D407-667-105
Job Sheet 164067

Part Name: Fwd Crosstube - High 407

DRAWING NO. D407-667-145	TITLE CROSSTUBE ASS'Y (407 HIGH FWD)	REV. C	DART AEROSPACE LTD ENGINEERING ORDER		D.E.O. NO. D407-667-145-C-1	SHEET NO. SHEET 1 OF 1	SCALE NTS
DRAWN 9P	CHECKED ASS	MFG. APPR. IB	APPROVED WD		DE APPR. H		
DATE 11.07.15	DATE 11.07.22	DATE 11.07.22	DATE 11/07/22		DATE 11.07.21

DRAWING NO. D407-667-145	TITLE CROSSTUBE ASS'Y (407 HIGH FWD)	REV. C	DART AEROSPACE LTD ENGINEERING ORDER	D.E.O. NO. D407-667-145-C-2	SHEET NO. SHEET 1 OF 1	SCALE NTS
DRAWN AJS	CHECKED	MFG. APPR.	APPROVED	DE APPR.		
DATE 12.08.02	DATE 12.08.02	DATE 12.08.02	DATE 12.08.02	DATE 12.08.02	DATE 12.08.02

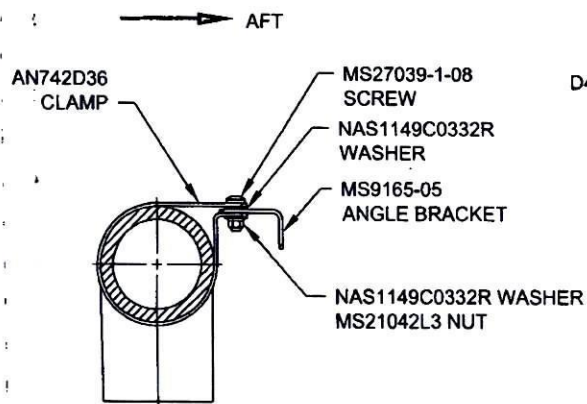
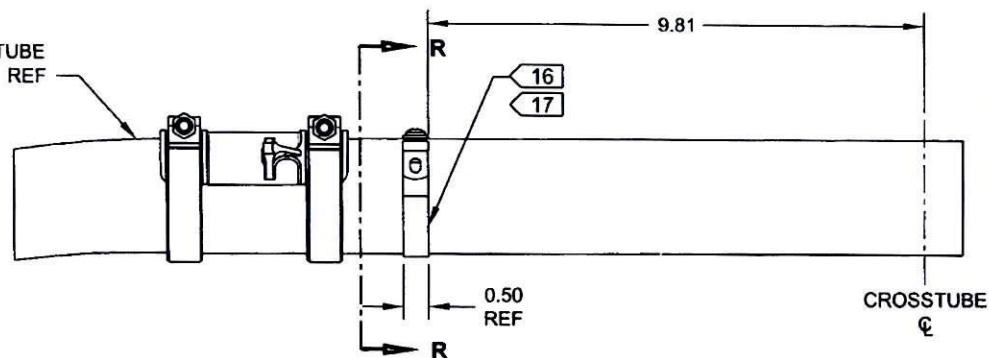
ADD ELECTRICAL GROUNDING STRAP

ADD

ADD

ITEM	QTY	PART NUMBER	DESCRIPTION
1	X	D407-667-145	CROSSTUBE ASSEMBLY (407 HIGH FWD)
10	2	AN742D36	CLAMP
11	2	MS9165-05	ANGLE BRACKET
12	2	MS21042L3	NUT (OR MS21042-3)
13	2	MS27039-1-08	SCREW
14	4	NAS1149C0332R	WASHER (OR AN960C10L)
